UNITED STATES PATENT AND TRADEMARK OFFICE

APPLICATION NO.	FILING DATE	FIRST NAMED INVENTOR	ATTORNEY DOCKET NO.	CONFIRMATION NO.
10/587,445	07/25/2006	Dieter Ramsauer	135408-2035	5304

Office Action Summary	Application No. 10/587,445	Applicant(s) RAMSAUER, DIETER	
	Examiner EMILY MORGAN	Art Unit 3677

DETAILED ACTION

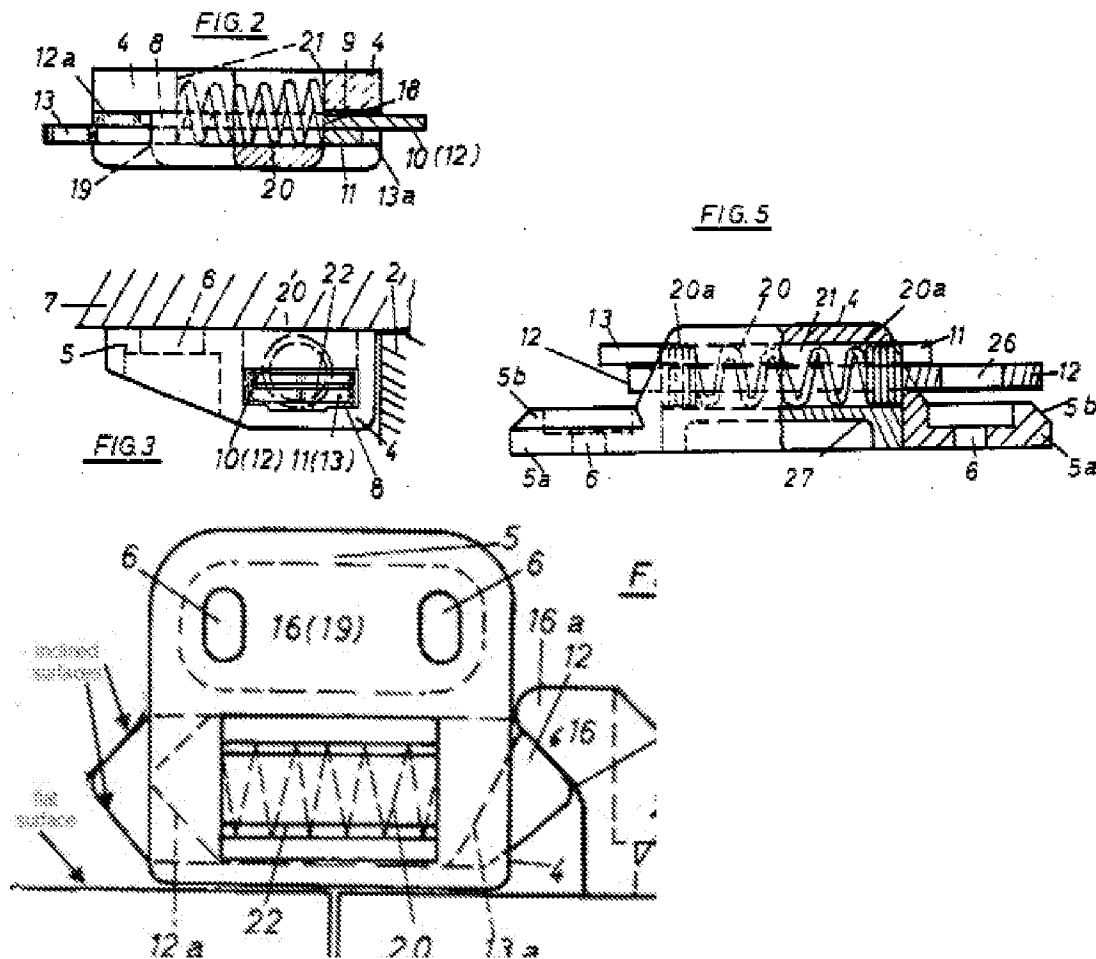
An expanding latching device similar to that taught by Gullong, having holding elements 12 and 13 are formed by two flat metal pieces lying next to one another (figure 5) with smooth surfaces, each metal piece having a rectangular opening 21, these two openings or breakthroughs together forming a rectangular space (figure 6) which receives a spiral pressure spring 20 by at least a portion of its diameter (figure 5).

Willimzik discloses two obvious variations on the relationship of the axis of the spring and the plane between the holding pieces. The first is shown in figures 2 and 3,

shown on the left, and the second is shown in figure 5, on the right. Examiner notes that the spring axis' relationship with plane between the flat pieces depends on either: the thickness of the flat pieces 12 and 13, or; the housing 4 holds the flat pieces 12 and 13 in relation to the spring's housing space 21.
